601 East Pike Street

CITY OF SEATTLE DESIGN REVIEW

RECOMMENDATION MEETING

DPD PROJECT #3015370

12/4/2013 EDG PREFERRED SCHEME C

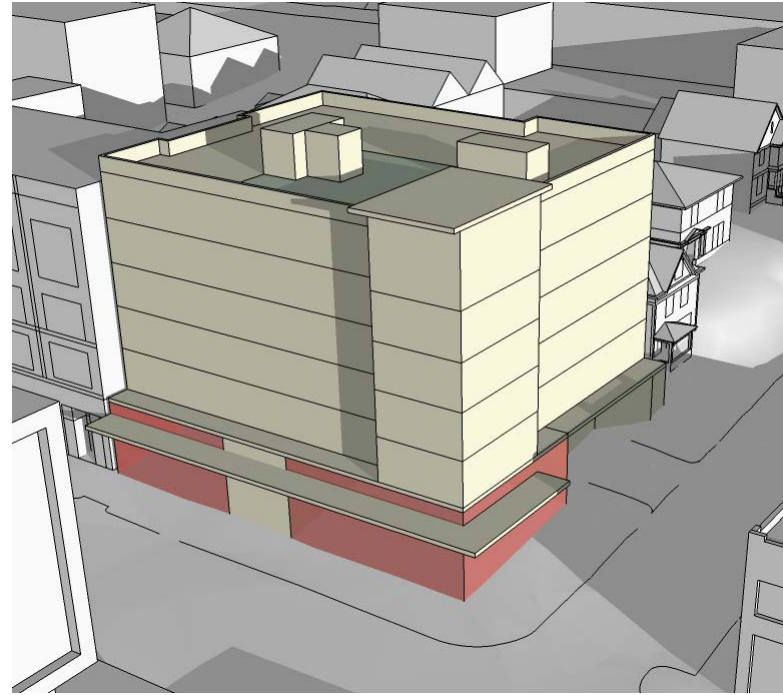
“A clear simplified and cohesive design concept should express the stacked flat building program. The design should include a hierarchy of clearly legible design moves, in response to the corner, adjacent conditions, and building program. “
(B-1, C-2, C-4)

The street level spaces should be designed to maximize human activity and human scale.”
(A-2, A-4, A-8, C-3, C-4, D-1, D-6, E-2)
“Enhance human activity on Belmont Ave. Possible solutions include incorporating the stairs inside the building and extending the retail frontage further up Belmont, locating the lobby on Belmont Ave, and moving the solid waste storage into the building to allow the parking entry to shift to the south to make room for retail or lobby street frontage. “
“Maximize contiguous retail frontage “
“The general location of the parking access near the southwest corner is the best option. The Board would be supportive of departures to minimize the visual and physical impacts of the parking entry on the pedestrian environment”.

“The proposed development should maintain at least the proposed 10’ setback from the adjacent site to the south.”
(A-5, B-1, C-2, C-4, E-2)
“Maximize light and air to the much smaller residential buildings and open space to the south.”
“An upper level setback on the south façade may help to reduce the appearance of bulk and scale to the south.”

VIEW ALONG BELMONT AVE.

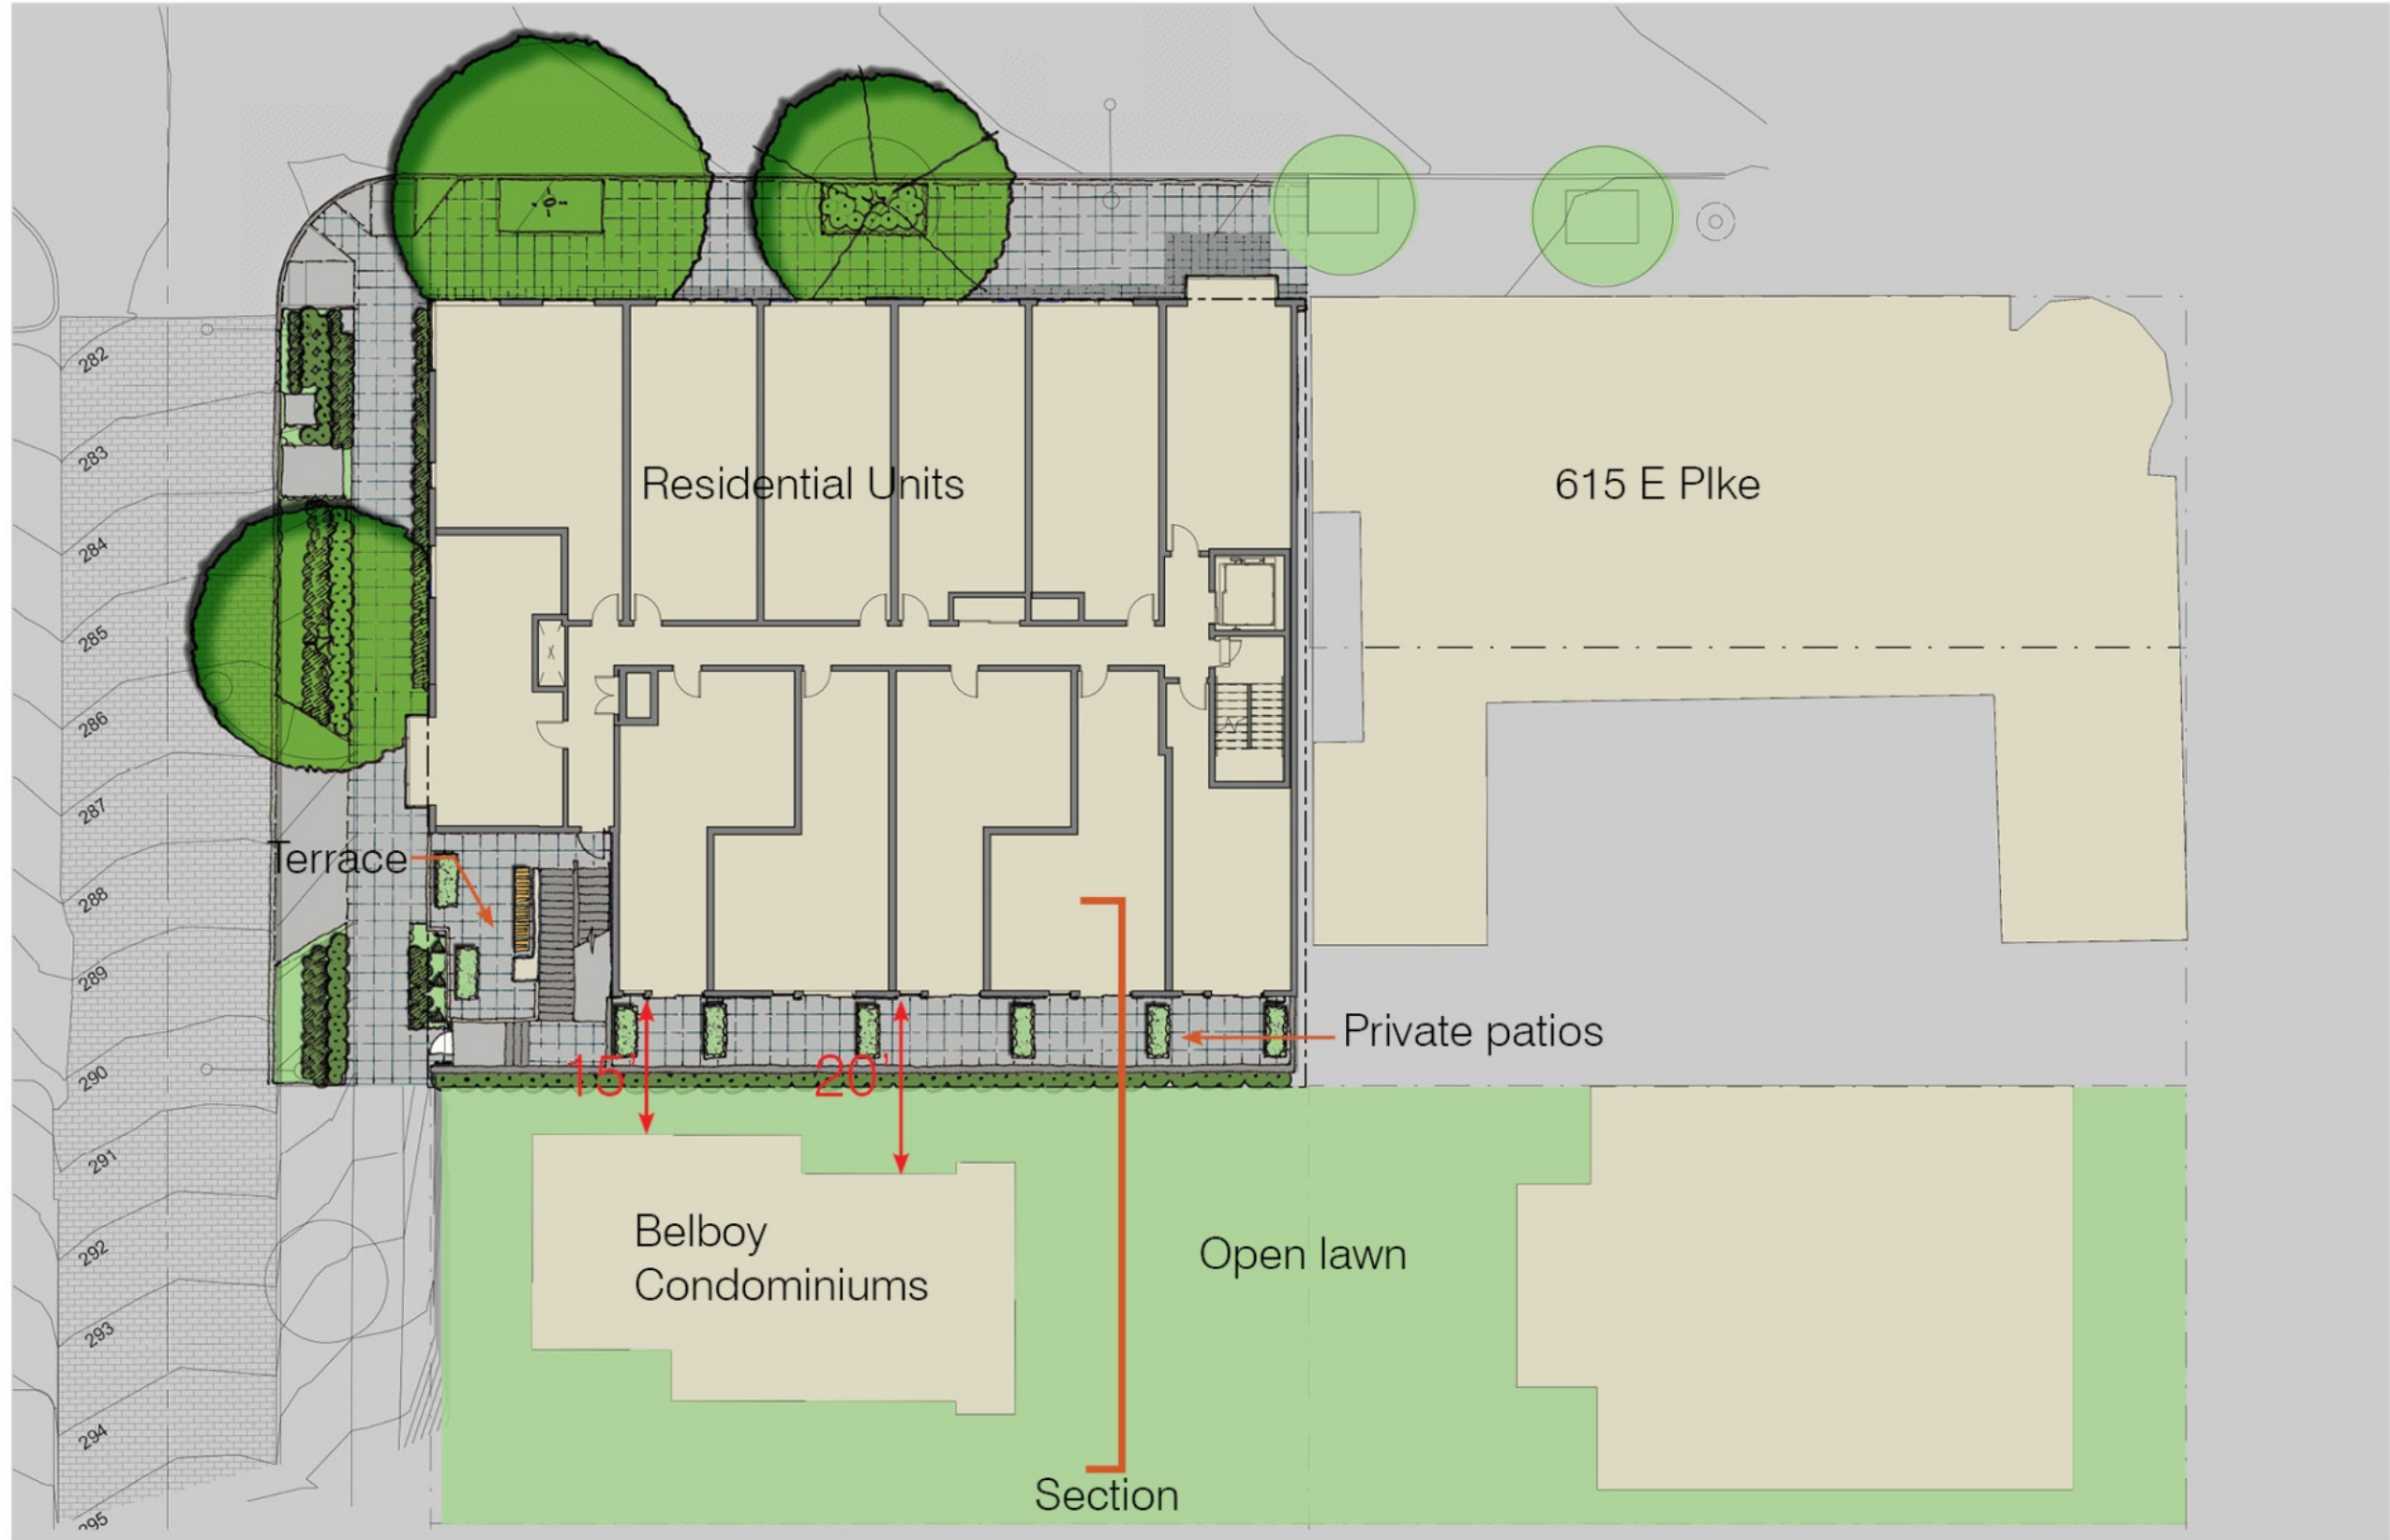
The west stair should enhance the overall design concept. The Board noted that the exterior stair as shown on the conceptual design images appears to conflict with the design concept and nearby context.

EXTERIOR STAIR INTEGRATED
WITH SOUTH ELEVATION.
READS AS BALCONY

PORCH CREATES RELIEF AND SCALE
THAT RELATES TO BELBOY PORCH,
IMPROVES SIGHT LINES TO AND FROM
BELBOY.

The secondary entrance and exterior stair has been relocated to the south side of the project. The stair connects to the sidewalk on Belmont by way of an expanded level three landing that serves as informal amenity space and has a scale that relates to the neighboring Belboy Condominiums. Moving the stair simplifies the Belmont façade, enlivens the pedestrian environment and allows retail to wrap around the corner onto Belmont Ave.

STRUCTURAL BUILDING OVERHANGS (SMC 23.43.035.A.4.C)

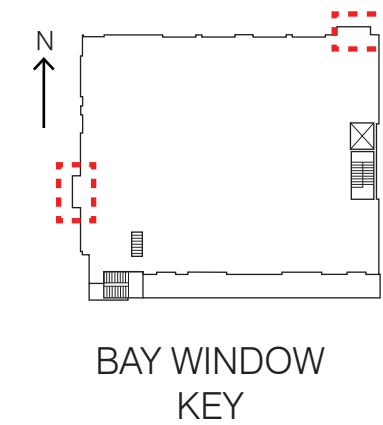
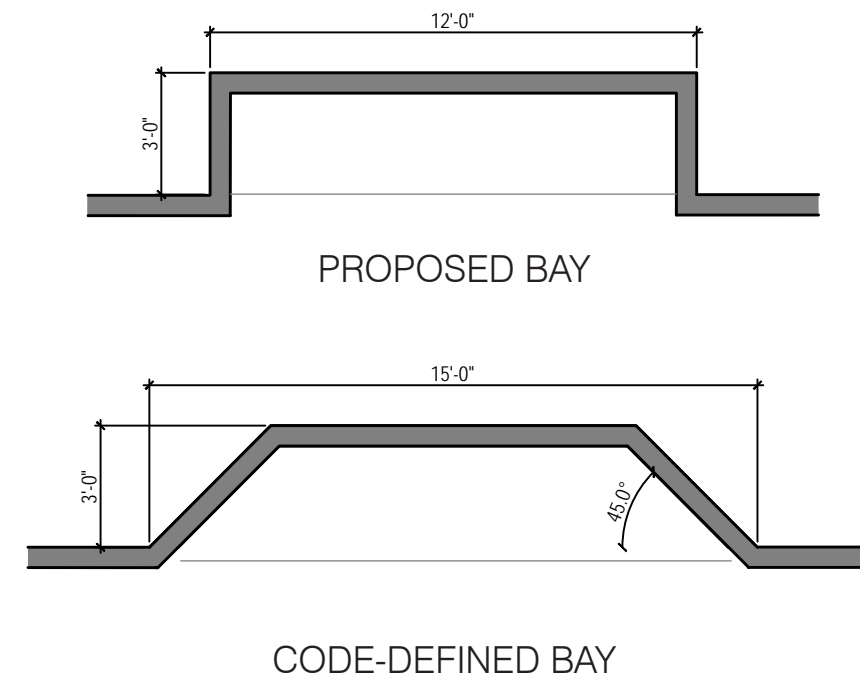
STRUCTURAL BUILDING OVERHANGS (SMC 23.43.035.A.4.C): Bay windows that extend into the right-of-way shall not exceed 15 feet long, 3 feet deep and shall have side walls angled at 45 degrees.

The applicant proposes a maximum 12 feet long and 3 feet deep with 90 degrees side walls with a projection of 2 feet 6 inches.

Bay windows with angled side walls are very traditional in appearance and would conflict with the proposed building's contemporary character. The enclosed area of each proposed bay is equal to that allowed in a code-compliant bay.

SIGHT TRIANGLE (SMC 23.54.0303.G.1)

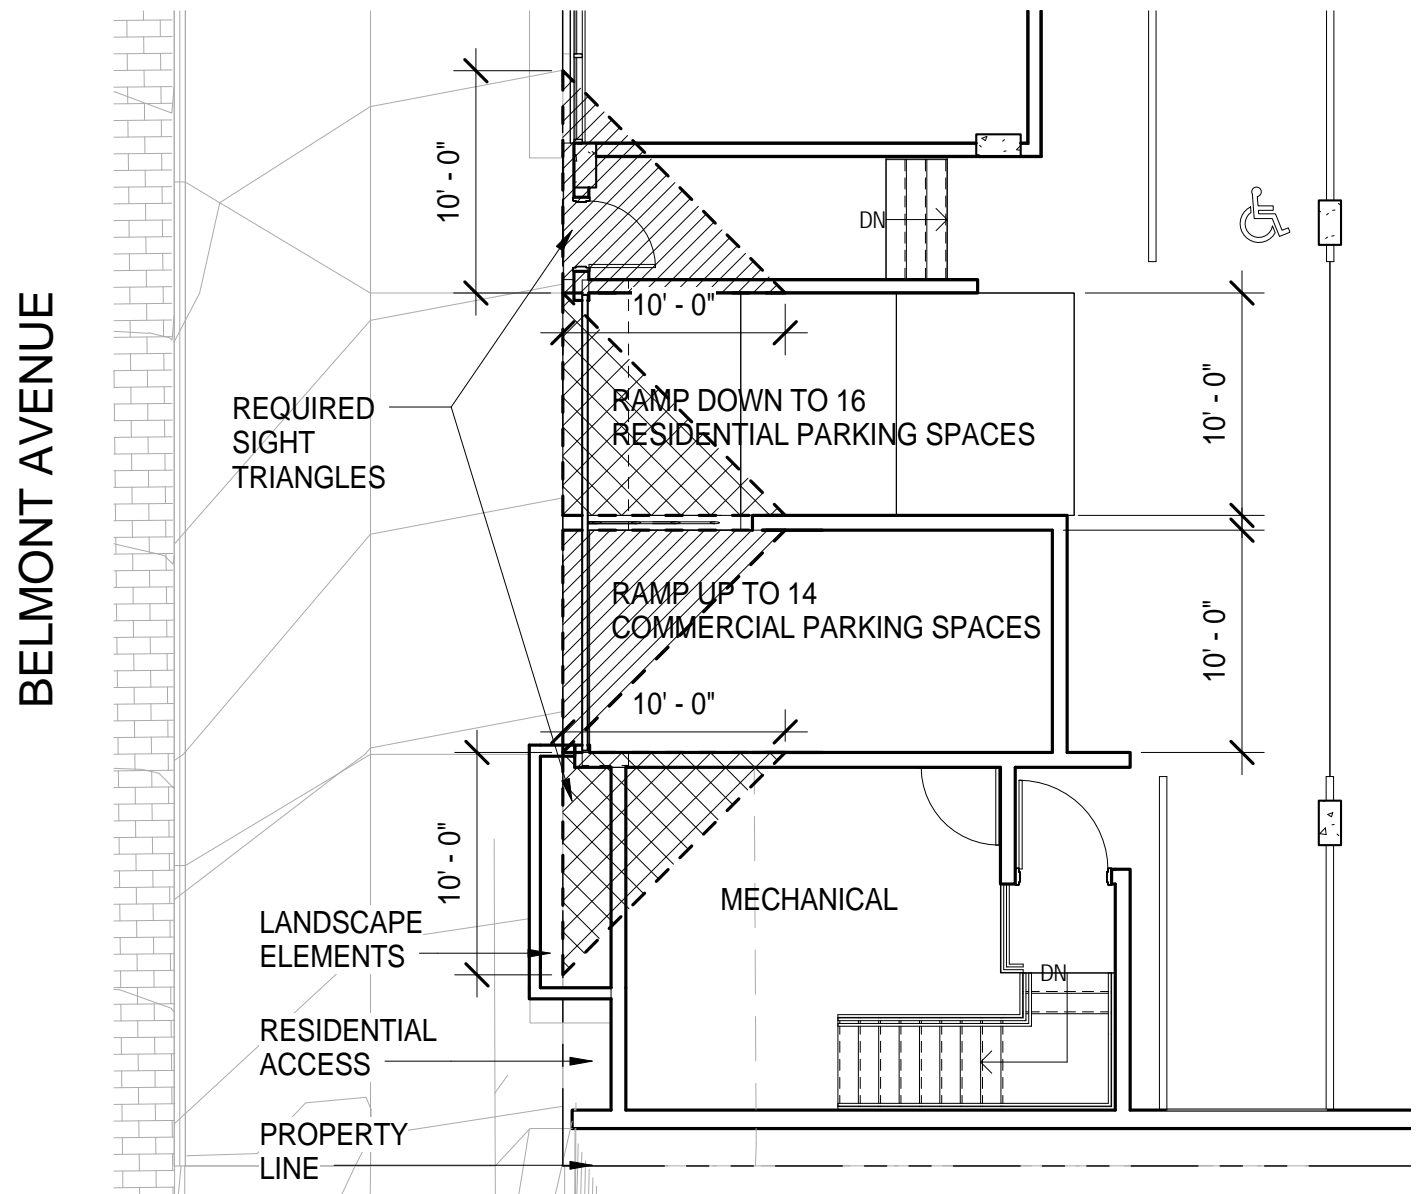
DRIVEWAY WIDTH (SMC 23.54.030.D.2): Minimum driveway width for nonresidential uses for two-way traffic shall be 22 feet.

SIGHT TRIANGLE (SMC 23.54.0303.G.1): A sight triangle is required on either side of a two-way driveway less than 22 feet wide.

The applicant proposes to provide a 10-foot wide driveway for 14 commercial parking spaces on level 2.

The applicant proposes to provide mirrors or other safety measures instead of the sight triangles.

Eliminating the sight triangles minimizes the appearance of the driveways, which would otherwise dominate the street-level facade on Belmont Avenue. Planted areas are proposed directly adjacent to the building in order to move the sidewalk away from the face of the building. All parking will be monthly rental in order to reduce in-and-out traffic.

STREET-LEVEL DEVELOPMENT STANDARDS (SMC 23.47A.008.B.3.B)

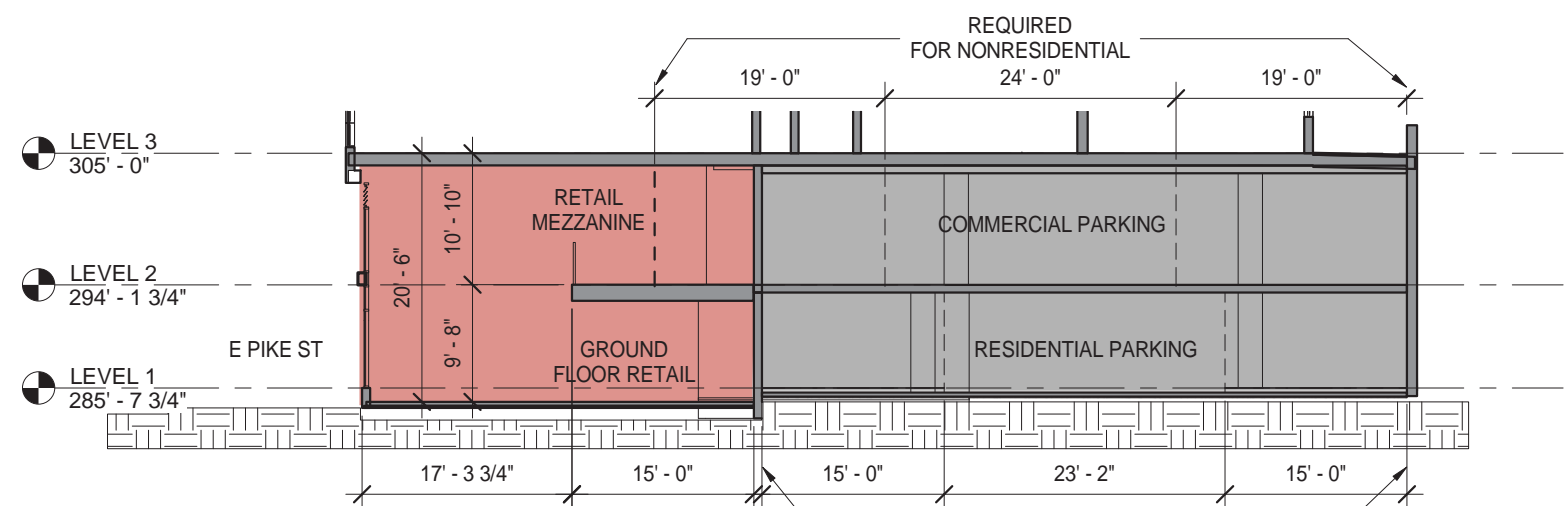
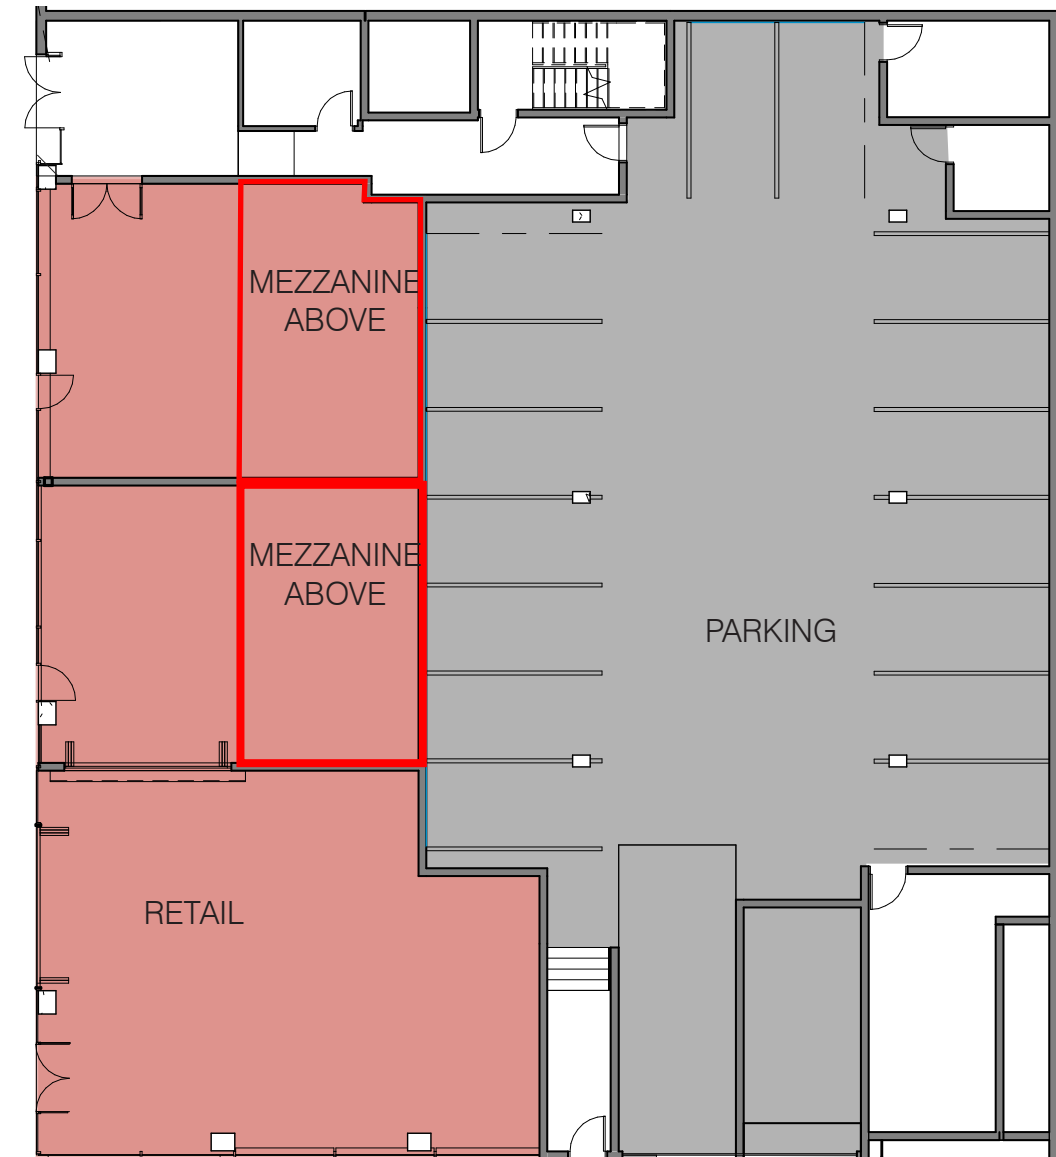
PARKING SPACE STANDARDS (SMC 23.54.030.B.2.D): When 20 or more parking spaces are provided a minimum of 35% of spaces shall be small vehicles (7.5 Ft. x 15 Ft.). A minimum of 35% of spaces shall be striped for large vehicles (8.5 Ft. x 19 Ft.).

STREET-LEVEL DEVELOPMENT STANDARDS (SMC 23.47A.008.B.3.B): Nonresidential uses at street level shall have a floor-to-floor height of at least 13 feet.

The applicant proposes to provide 100% of the 14 commercial spaces as small vehicles.

Because of the shallow lot depth (90 Ft.), large parking spaces would encroach on the proposed retail mezzanines. These mezzanines mimic those found in other buildings in the neighborhood, such as the 615 E. Pike building, the Pineway, and increase the viability of the commercial space. The proposed departure matches the standard allowed for the project's residential parking.

The applicant proposes to provide retail mezzanines with a minimum 9 foot floor-to-floor height.

The overall floor-to-floor height of the retail spaces is a minimum of 20'-6", a height that provides the opportunity for mezzanines like those found in other buildings in the neighborhood, such as the 615 E Pike building and the Pineway. Combined with the generous transparency at the perimeter, the mezzanines help create dynamic and appealing retail spaces
